Northgate Pedestrian Bridge

Meeting Summary

This was the Seattle Design Commission's (SDC) fourth review of the Northgate Pedestrian Bridge project. The purpose of this meeting was to review the schematic design phase. After the presentation and discussion, the SDC voted 8-1, to approve the schematic design for the Northgate Pedestrian Bridge with several recommendations.

Figure 2: Updated alignment proposal

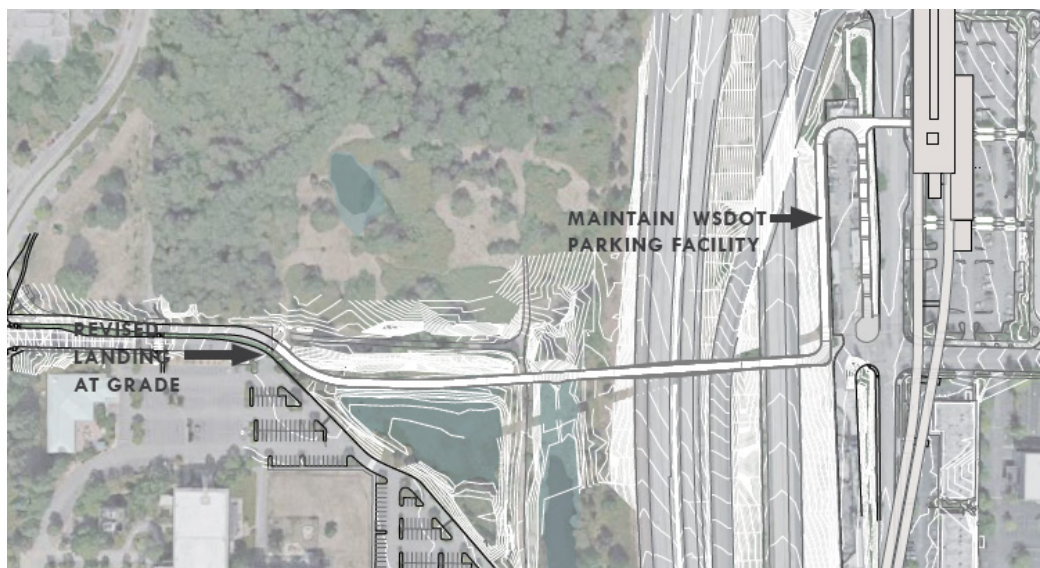
The SDC commended the project team for revising the bridge alignment which will reduce the slope of the bridge and provide greater neighborhood connections. Commissioners are still concerned with the proposed 8% slope between the light rail station mezzanine level and 1st Ave NE landing and mixing zone, specifically as it relates to increased cyclist speeds. Although the SDC agreed with updates to the proposed mixing zones, several commissioners encouraged the project team to use different paving materials and additional planting near the transition between the bridge pathway and the 1st Ave mixing zone as an additional visual cue for cyclists to slow down prior to entering the space. The commission also encouraged the project team to consider adding a stairway, connecting the 1st Ave mixing zone to the bridge above, in order to reduce travel time.

Figure 3: Proposed paving materials near mixing zones, transition zones, and overlooks

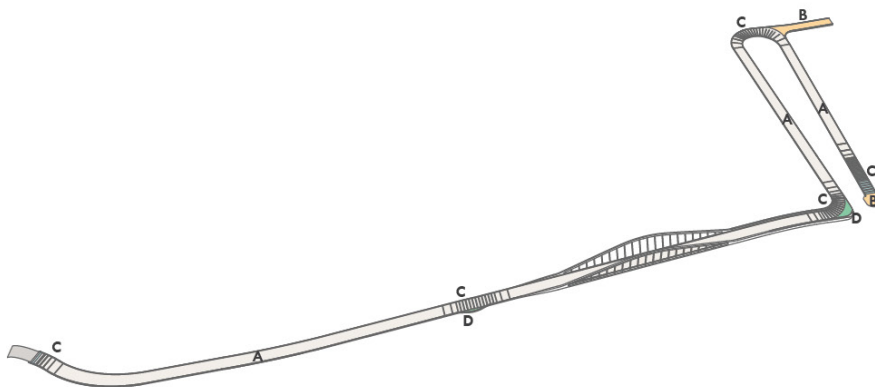
The SDC recommended the project team consider paying more attention to the materials used as well as the overall design of the thermoplastic bands, suggesting the bands could serve as another artwork on the surface of the bridge. Commissioners also reminded the project team to assess the durability of materials used for the bands.

1. Provide more details about how the bridge columns are integrated with the overall design
2. Quickly advance the landscape plan to the level of detail found in the proposed bridge design
3. Consider alternative locations for artwork so that it is better integrated with the design of the bridge
4. Consider paying more attention to the materials used as well as the overall design of the thermoplastic bands

Figure 4: Proposed artwork concepts

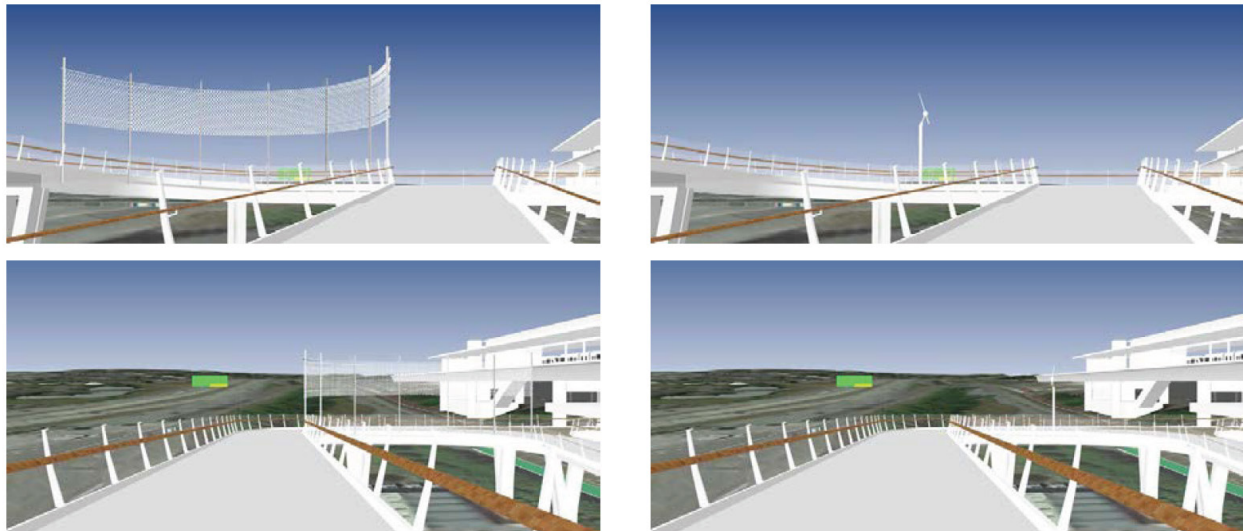
The SDC agreed with the layout and design of the proposed mixing zones. While the Commission preferred the wind pixels artwork, commissioners had differing opinions over the location of the artwork. Several commissioners thought the artwork should be located near the center of the bridge, while others preferred the currently proposed location, as it would be viewed from several different viewpoints. The Commission recommended the project team consider alternative locations for artwork so that it is better integrated with the design of the bridge.
